RAINIER & GENESEE MIXED USE

4208 RAINIER AVENUE SOUTH - SOUTH DEVELOPMENT

City of Seattle Design Review
Administrative Recommendation
DPD Project #3036324-LU

1a facade depth

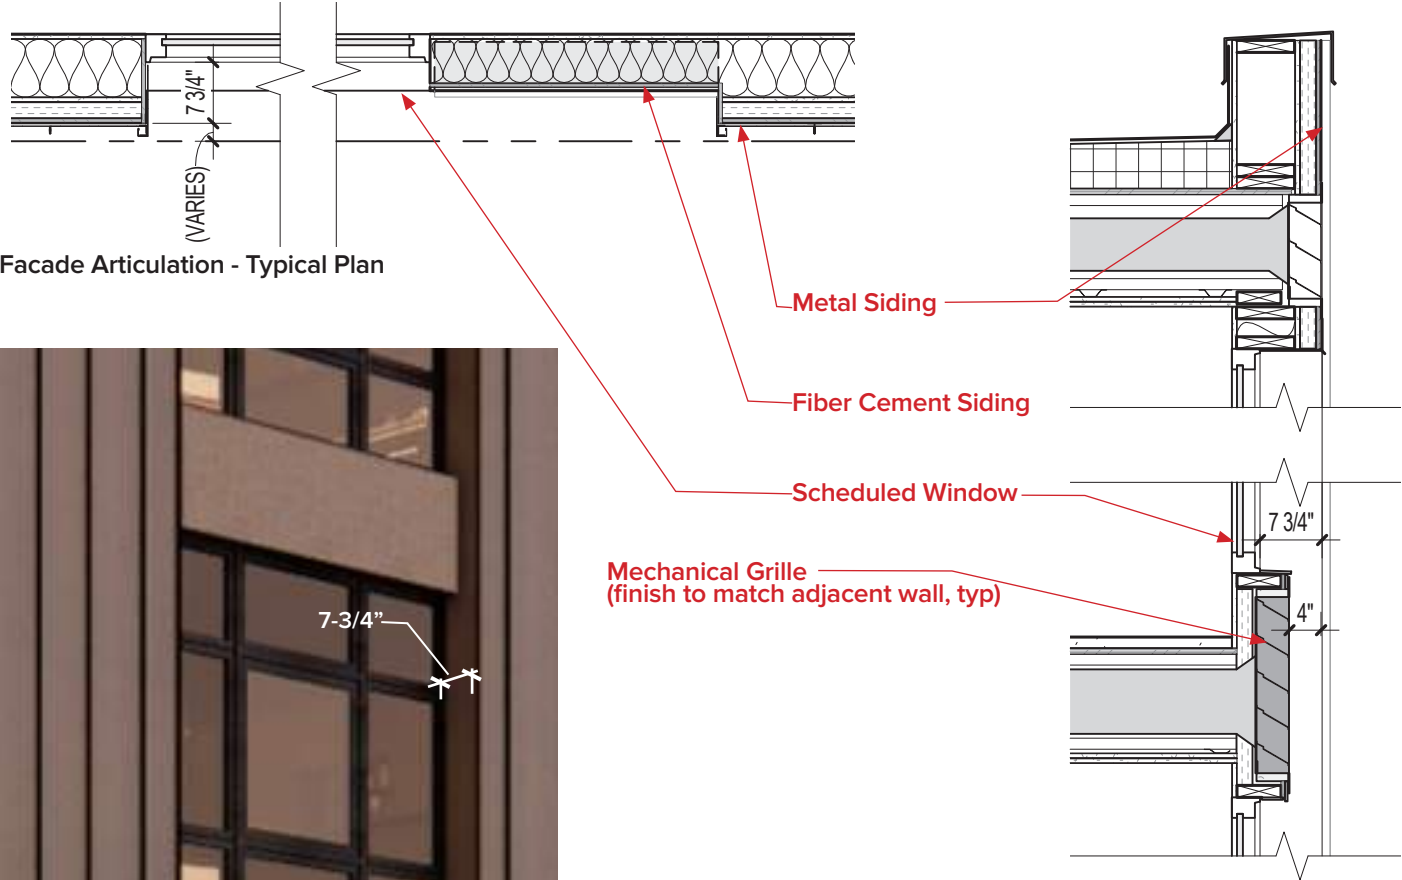
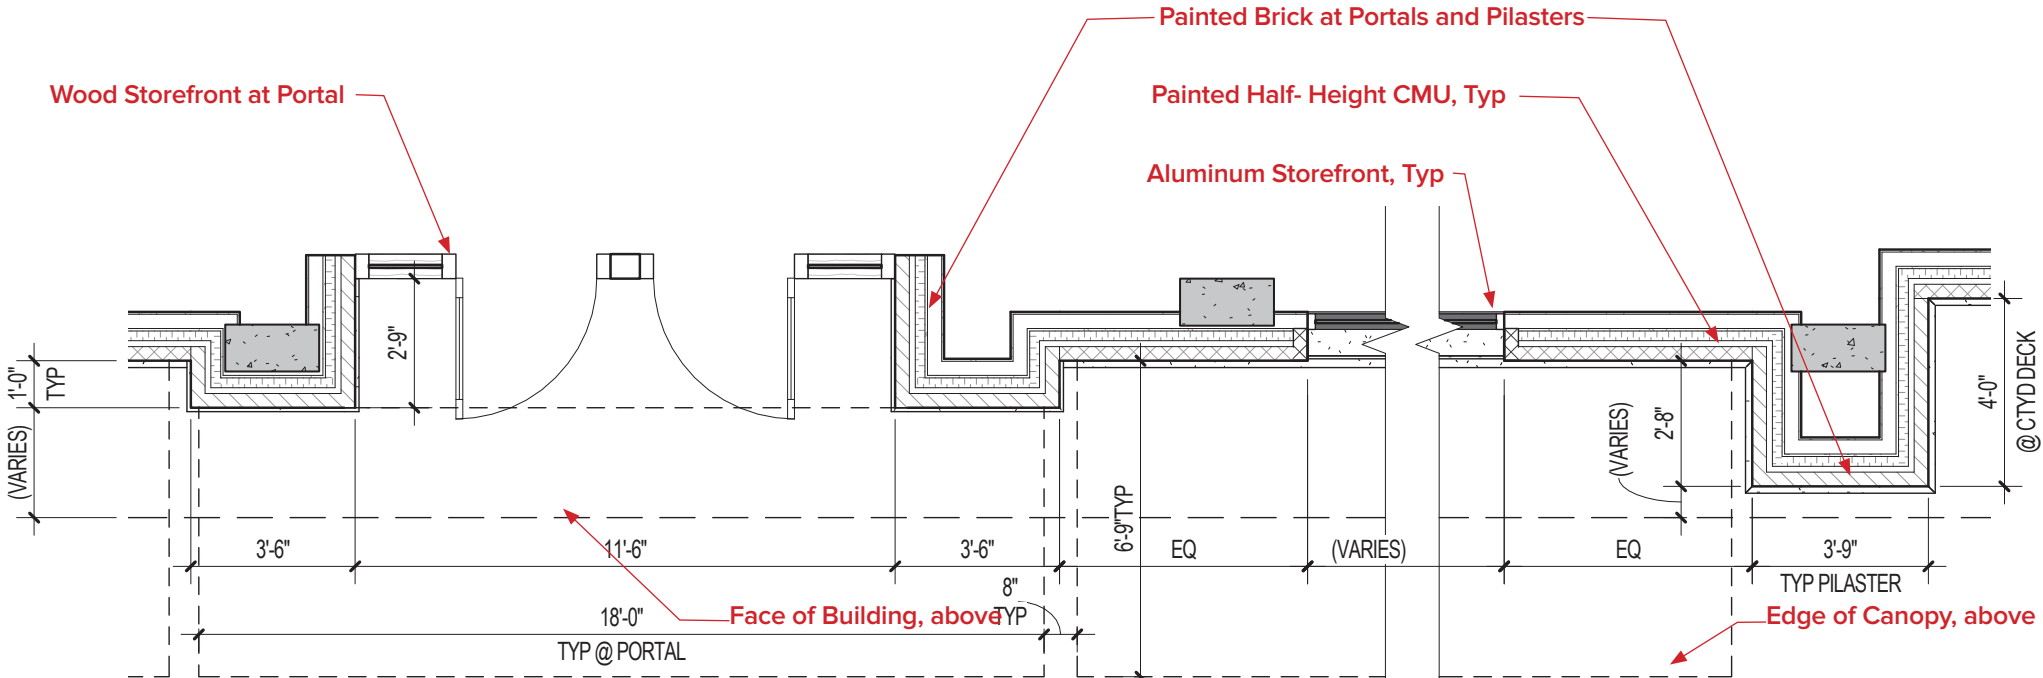
1a. Staff supports breaking up the perceived bulk of the upper level massing through facade articulation/material treatment and the use of secondary architectural elements. Maintain the 7 3/4" depth proposed from face of the siding material to the window bays. (DC2-A-2. Reducing Perceived Mass, DC2-C-1. Visual Depth and Interest)

RESPONSE:
The building design has been further developed to highlight articulation through refinement of the material palette (see page 33) and reconsideration of the facade to bring consistency to the north and south portions of the building. We have also maintained the 7 3/4" depth from face of siding to face of glazing (see adjacent snippet).

- 3c) retail tenant(s)
- 3d) pedestrian experience at ground level

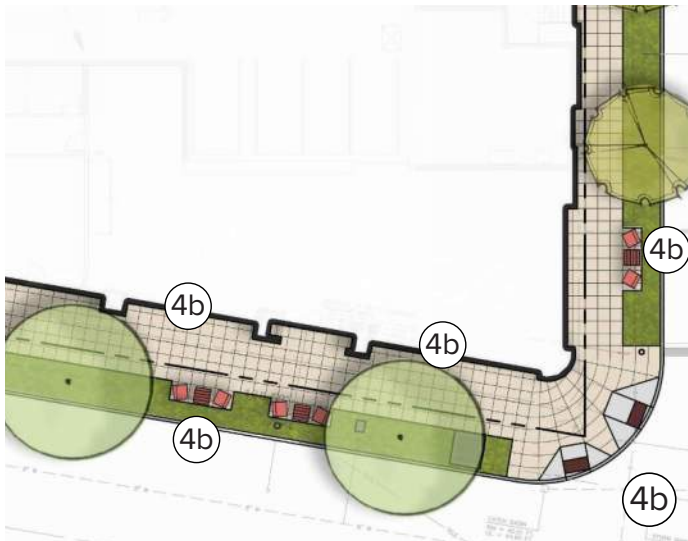
3d. Pedestrian Experience at the Ground Level: Staff is concerned with the design of the commercial space as proposed, which has a repetitious language that wraps around the southern portion of the building. Include various pedestrian scaled elements along the commercial frontage to add some variety and break down the linear nature of the glass storefront. (CS2-C-3. Full Block Sites)

RESPONSE:
With the change to smaller retail spaces, the ground level commercial frontage has been revised to add more variety and texture to the facade, incorporating brick pilasters and portals at Retail entrances. Planters, site furniture and other smaller scale site elements have also been added to the facade to break up the repetition and provide visual interest as well as areas for gathering and respite.

Courtyard 2 South Elevation

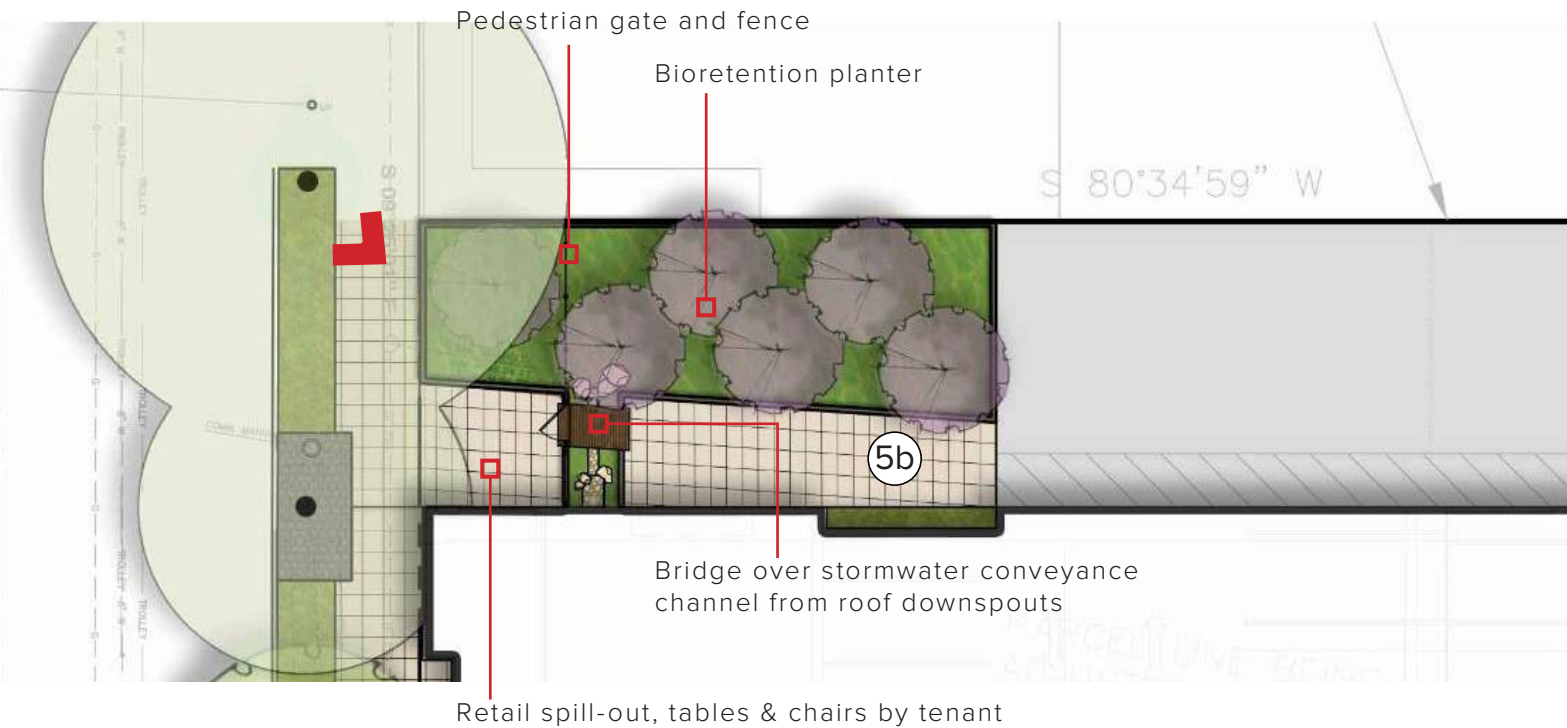
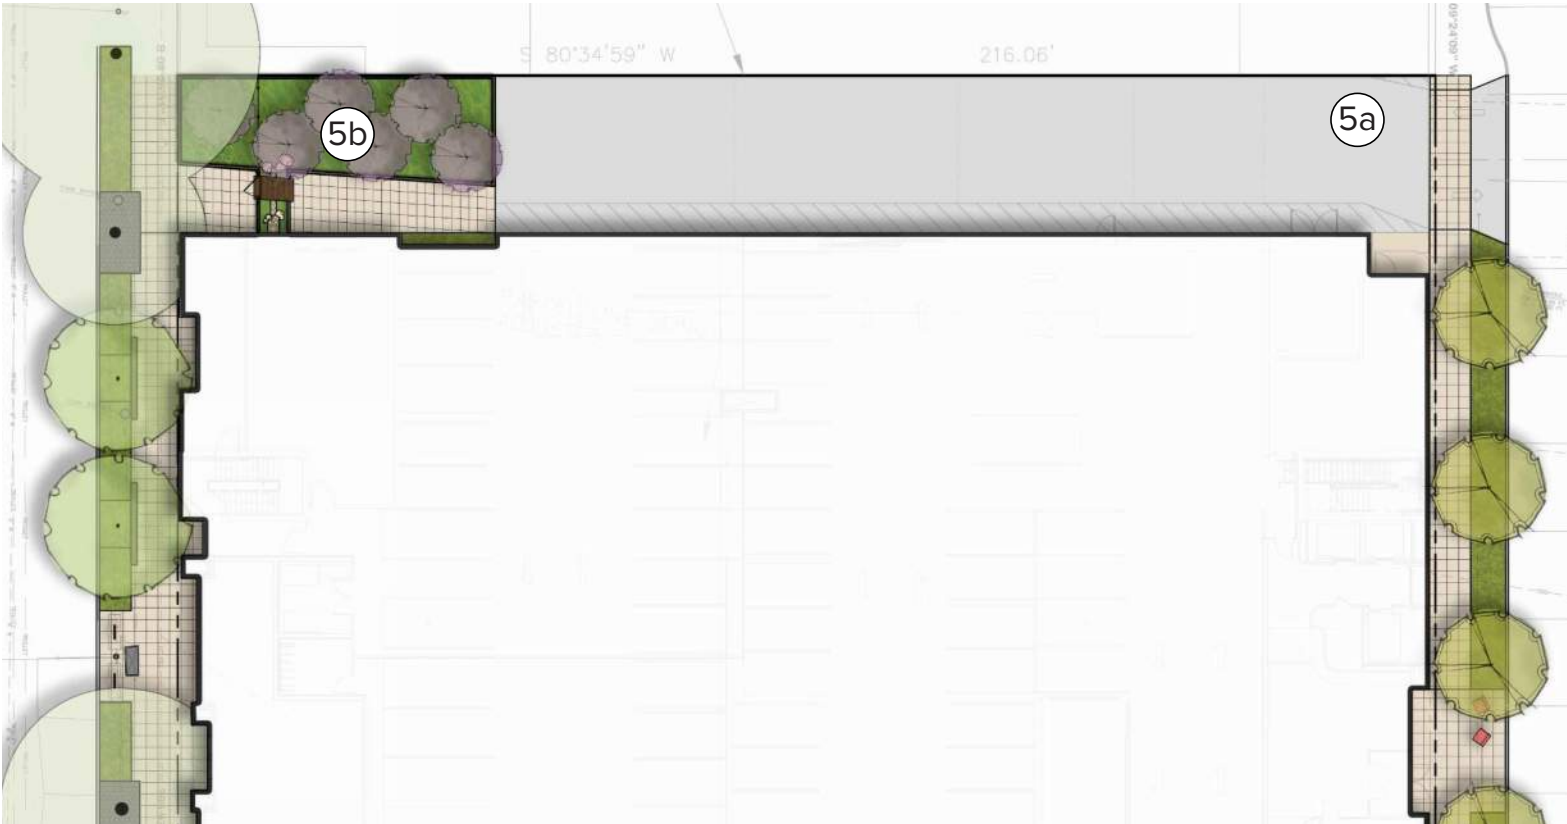
4a. Staff is concerned with the configuration of the upper level courtyards as proposed, which are very long and narrow. Improve the spatial experience by utilizing a lighter colored material for these interior facades to help reflect light into these spaces. Staff also recommends using vegetation and hardscape materials to break down the larger courtyard into smaller, more intimate spaces. Explore how the intended usability of these areas will continue to influence the design as the project evolves. (DC3-B. Open Space Uses and Activities, DC3-C-2. Amenities/Features)

RESPONSE:
Courtyard materials were studied and specified to provide interesting and varied materials on the facades and allow for depth in light penetration into each unit. Expansive unit windows and a shift in angles complimented by the courtyard landscapes, trees, and mis-aligned views create veils of privacy without sacrificing light and livability.

D1 facade modulation

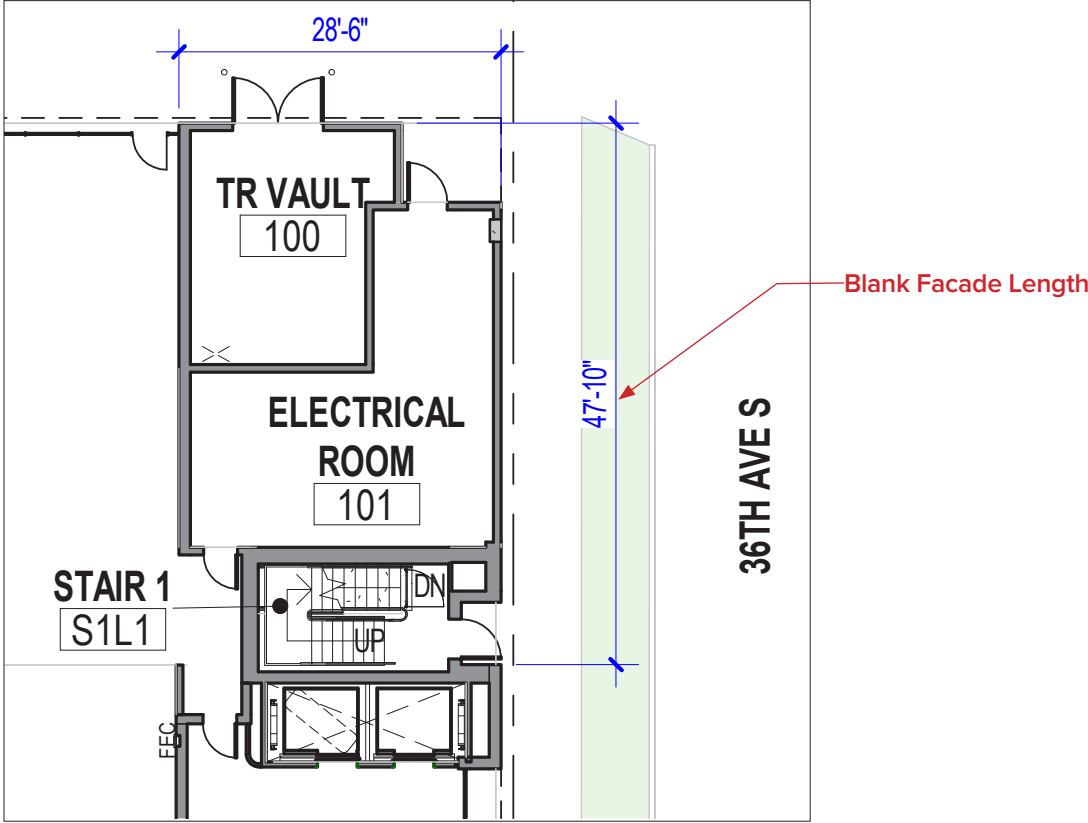
D1. Facade Modulation (SMC 23.47A.014.D): For structures with a width of more than 250 feet, at least one portion of the structure 30 feet or greater in width must be set back a minimum of 15 feet from the front property line. The applicant proposes setting back a 27-foot wide portion of the structure 4-6 feet at the base along Rainier Avenue South. The upper level massing for this portion of the structure is set back more than 15 feet.

Staff preliminarily supports this departure based on the design of the revised massing, which proposes a setback at the ground level that is deep enough to accommodate pedestrian amenities to help improve the experience along Rainier Avenue South. The void in the upper level massing also helps break the building into two distinct massing forms. Staff recommends incorporating a combination of elements (landscaping, seating, etc.) to make the area at the ground level more aesthetically pleasing. *PL1-B-3. Pedestrian Amenities*

RESPONSE:
Landscape elements and site furniture are intended to occupy the ground-level setback, and, along with the proposed mural, are intended to make the area at ground level more aesthetically pleasing.

D2 blank facades

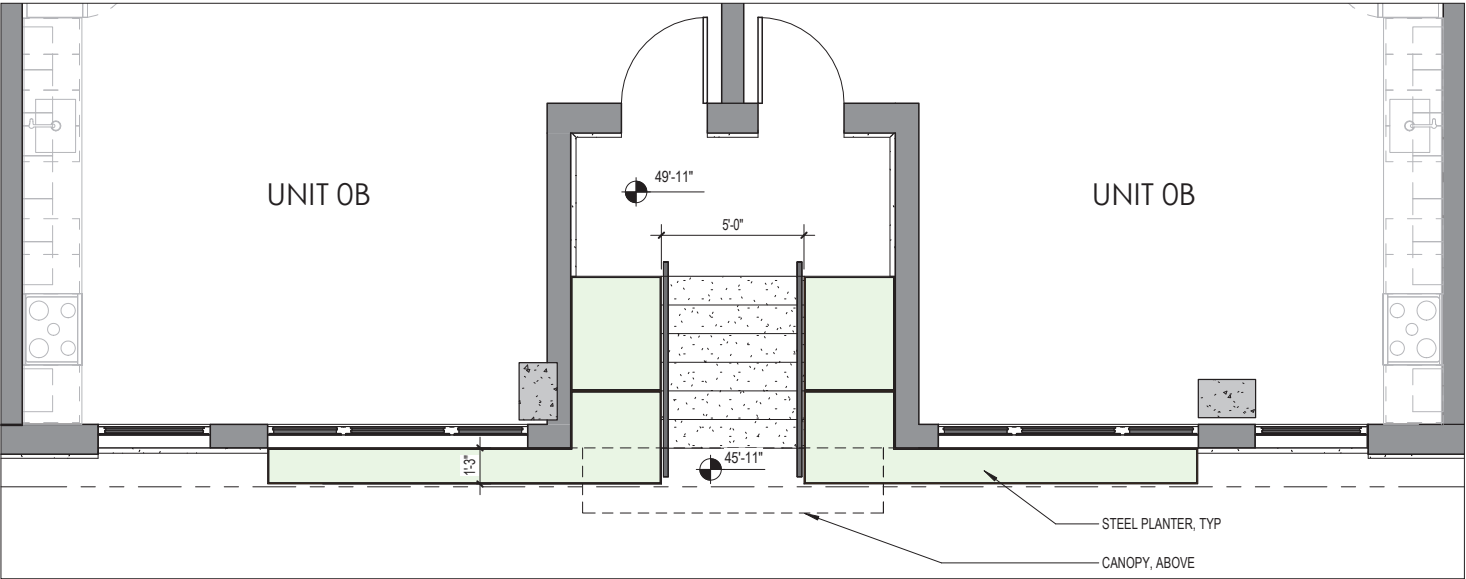
D3. Street Level Development Standards (Blank Facades) (SMC 23.47A.008.A.2): For structures in Neighborhood Commercial zones, the Code requires blank segments of the street-facing facade between 2 feet and 8 feet above the sidewalk not exceed 20 feet in width. The proposed design includes a 45'-3" blank wall segment along Rainier Avenue South.

Staff does not offer preliminary support for this departure as proposed and is concerned with only using the mural to mitigate the negative effects of the blank wall on the pedestrian realm. Staff recommends increasing the glazing at the ground level for this portion of the structure and incorporating landscaping at the breezeway deck provided on the second level to strengthen the connection to the street. Staff also recommends developing a design that incorporates various elements to support the proposed mural to minimize the impact to pedestrians. Also provide additional information on the artist and the design concept for the mural. *CS2-B-2. Connection to the Street, DC2-B-2. Blank Walls*

RESPONSE:
Glazing at the ground level has been increased along Rainier Ave S such that a departure is no longer needed at this location. See page 14 for revised street level elevation along Rainier Ave S. However, design evolution has led to a different blank facade location along 36th Ave S. Because this area encloses building utilities, additional glazing would not provide views into meaningfully occupied spaces. Proposed mitigation is a site-specific art installation, adding energy and color to the blank facade area, and continue around the corner to the north elevation to enhance the connection between the north and east facades.

D3 ground level residential

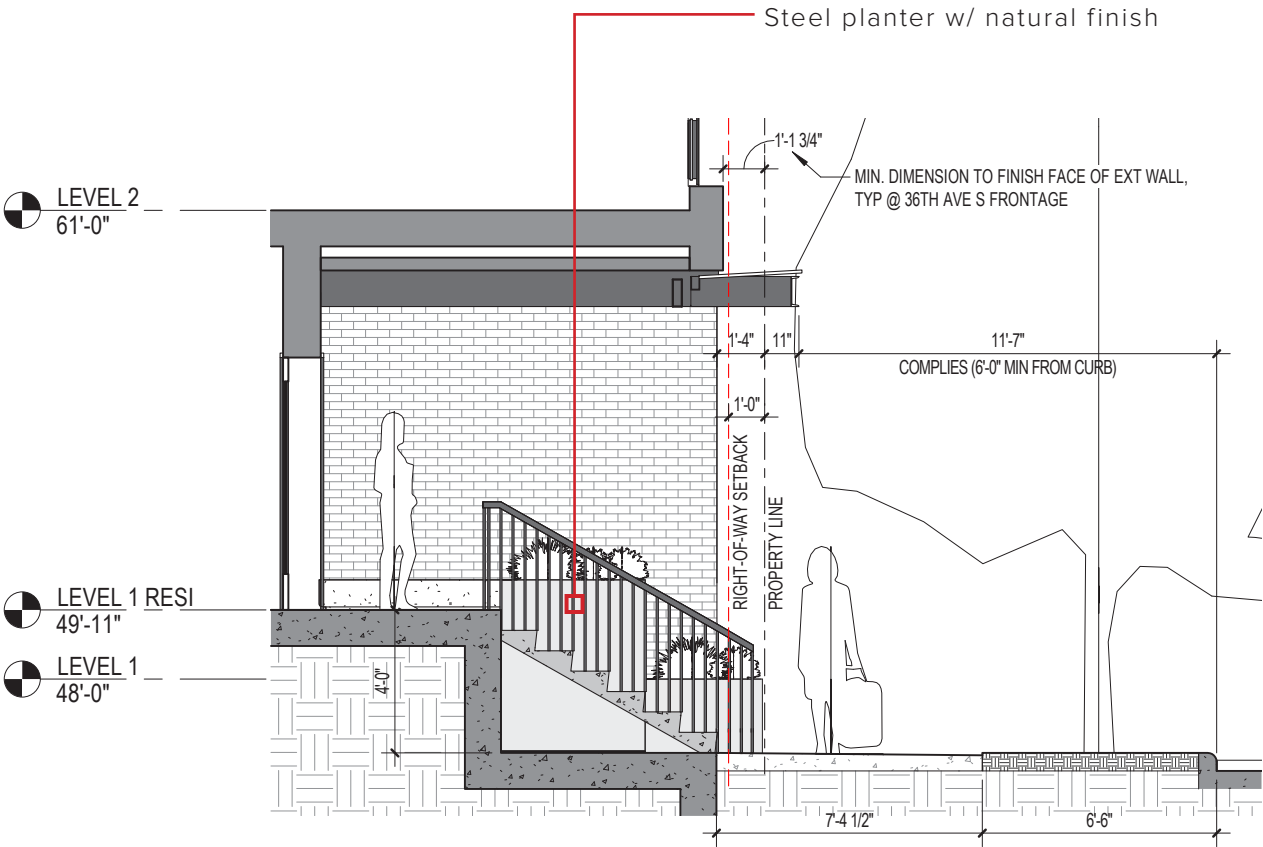
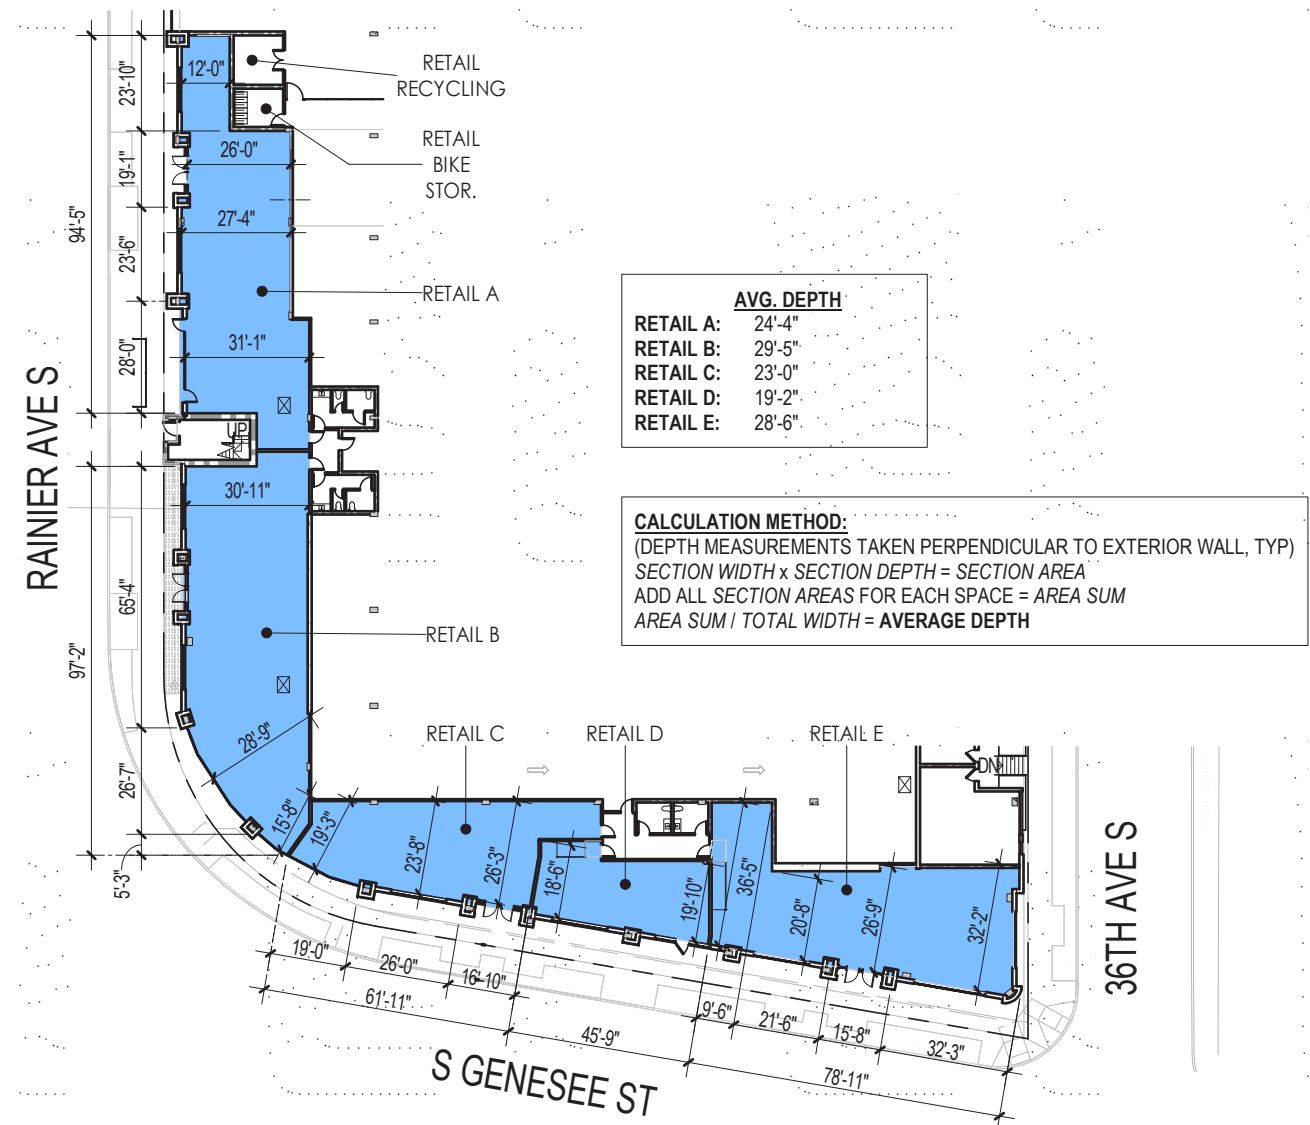
D1. **Street Level Residential (SMC 23.47A.005.D):** Referenced section lists conditions where residential uses may be located at street level by right, however this project does not meet the conditions of that section. The applicant is proposing 4 ground-floor units complying with the requirements of 23.47A.008.D.

RESPONSE:
36th Ave S is the quietest street frontage on the site, facing residential areas of the surrounding neighborhood. The main residential lobby and leasing office are also located along 36th, due to its adjacency to surrounding residential, and additional ground floor units contribute to the residential feel of the street. Residential entrances are on average elevated +4'-0" from the sidewalk.
